Misleading Substation Information

Speech: DCO Planning Hearing – Substation Renderings

Figure 10: View from BW0505016 towards Morgan substation, showing an indicative layout

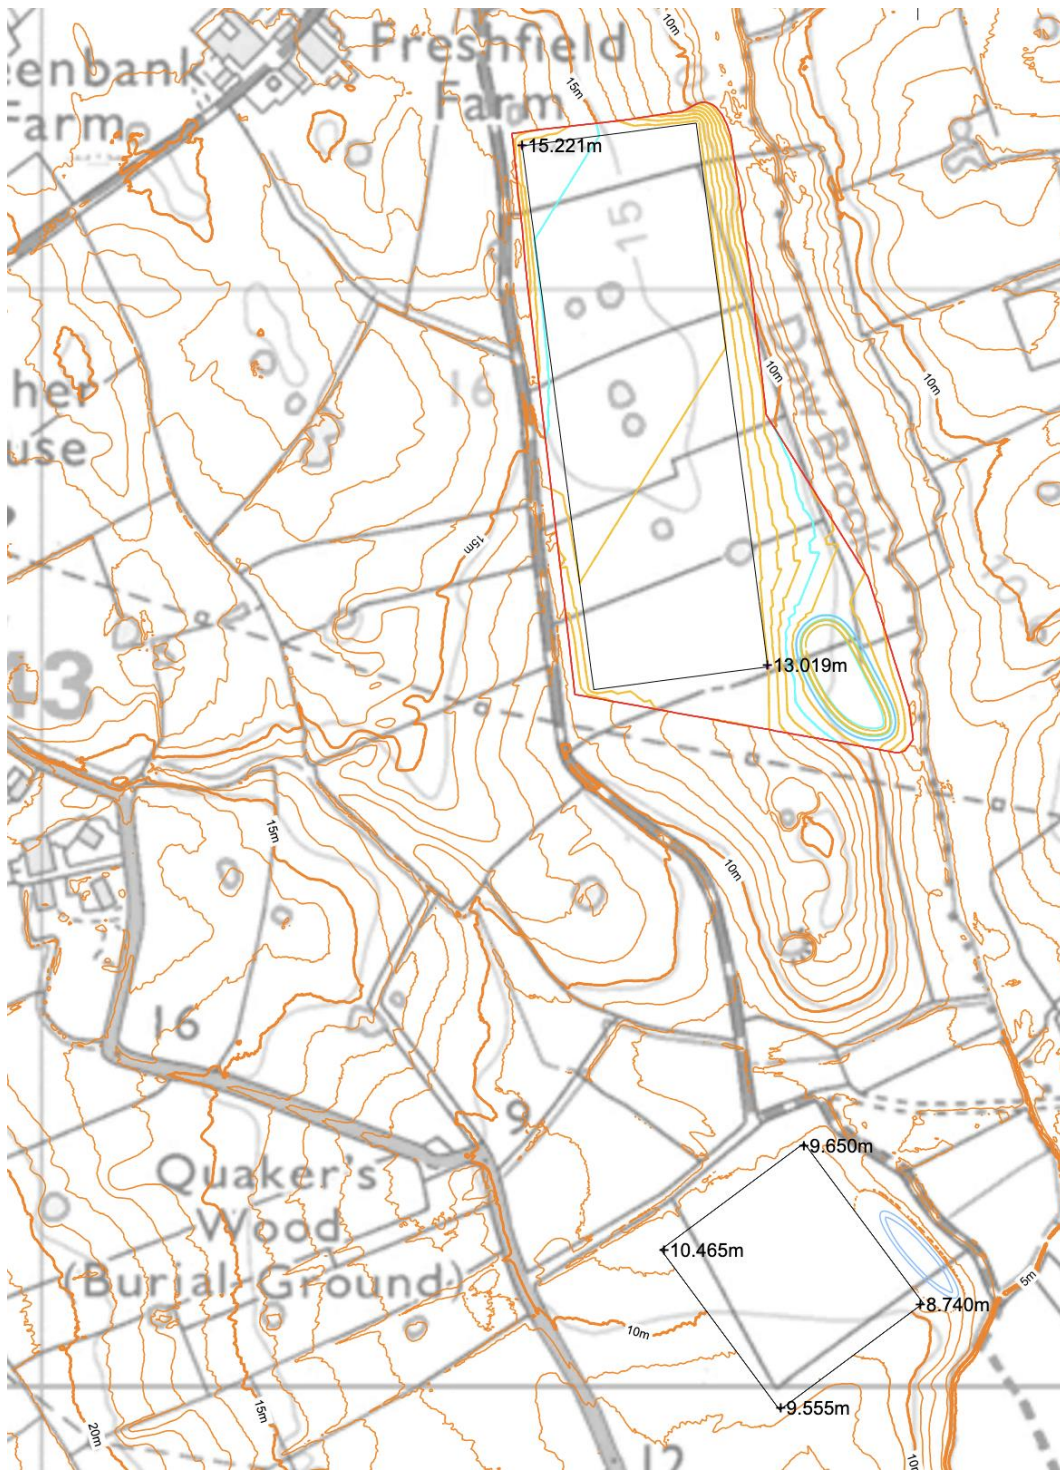
I mentioned the Outline Design Principles from September 2024 which included just two images, which appear misleading. In Figure 10, for instance, trees are shown taller than the 30-metre lightning masts—an unrealistic portrayal that risks misinforming both public and planning officials.

The Outline Design Principles from September 2024 included just two images, which appear misleading. In Figure 10, for instance, trees are shown taller than the 30-metre lightning masts—an unrealistic portrayal that risks misinforming both public and planning officials.
